DEVELOPMENT REVIEW BOARD REPORT

110-DR-2005
The 4020 Building

Request to approve site plan, elevations, landscape plan, and lighting plan for a proposed adaptive reuse of an existing office building into a proposed 3-story mixed use (residential and retail) structure.

**A5
BUILDING
ELEVATIONS**

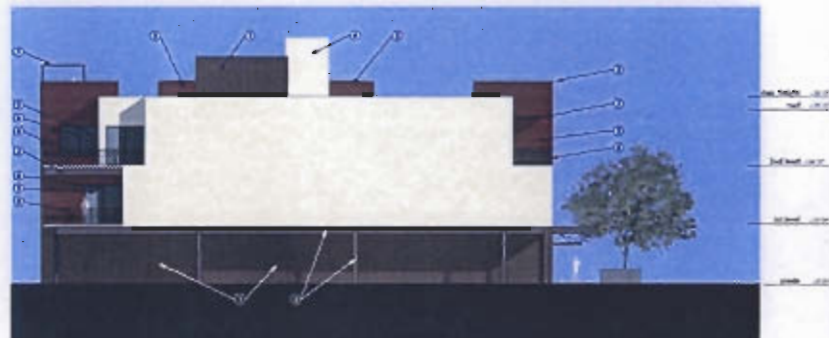
The proposed building, while not as drastic a departure from the surrounding architectural style, as the first submittal, is still fairly modern in its approach to creating vertical elements. The use of squared edges, boxy forms, and the selected materials (see below) create the look and feel of a modern structure in the context of old west buildings created of red brick and / or Santa Fe style adobe construction. This dichotomy creates conflict, which is further exacerbated in the context of the Baja Fresh / Starbuck’s building to the north, which is also built using a building skin which features traditional brick (i.e., buildings directly to the north and south). While the proposed modern style has definitely been successful in the marketplace, its placement at this location, directly adjacent to the Old Town area, is inappropriate in its contextual response to the surrounding environment.

The applicant is proposing a building skin of brown brick, painted hardiplank, bronze storefront, and aluminum. The Old Town design guidelines contemplate wood siding (i.e., board and batten, tongue and groove, etc.), flat finish opaque or transparent earthtone colors, with stucco, stone or brick below sill heights.

As noted above, the subject parcel is not formally located inside the Old Town boundary. However, being adjacent to Old Town on two sides makes the contextual response of this building important to the long term ability to retain the character of the Old Town area. The proposed brick and hardiplank are somewhat out of character for the area, which includes a more traditional red brick and / or wood/board and batten façade on most buildings in the Old Town area. Additionally, the cable railing proposed for the balconies, in conjunction with the bronze and aluminum used as accent materials on the structure, are out of context in an area usually associated with the old west.

Have been looking at the 4020 building (sideways of course). Changing to the brick is better and glass reduction better.

While there are some stepbacks on the building it still remains mostly straight up.

Are the windows set back in or flush with the building. Should be recessed.

Westside looks flat - like an after thought.

Has the developer considered the three surrounding buildings special detail elements. Starbucks, Shipp Plaza, Chase - Maybe something like soldiers style brick at each level.

On the ground level for retail is there a lower panel design so it would not have the glass running from top to bottom. See the windows on the Chase building.
